WORTHINGTON, SKILLING, HELLE & JACKSON — Civil & Structural Engineers

PROJECT: THE WORLD TRADE CENTER | TITLE: EXTERIOR WALL – DETAIL 7 | DATE: 6-5-67

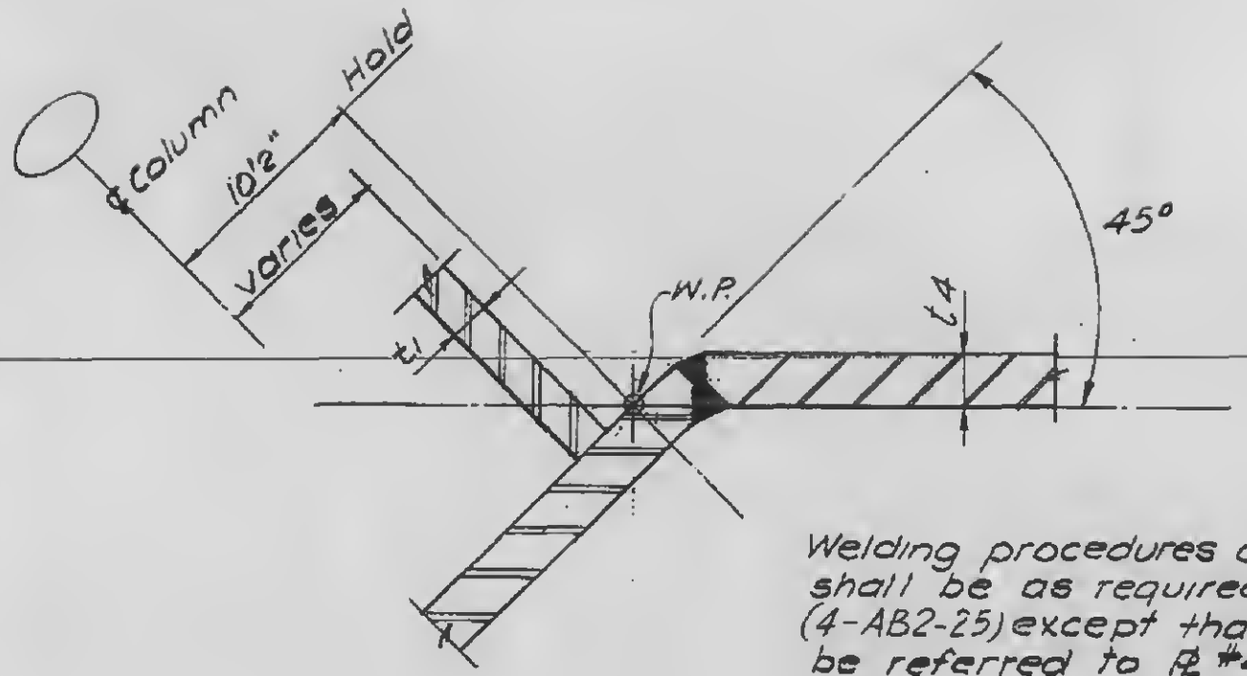
At fabricators option Detail 7 may be used in place of Detail 6.

Welding procedures and electrodes shall be as required for Weld #10, (4-AB2-25) except that welds shall be referred to PL #4 instead of PL #3.
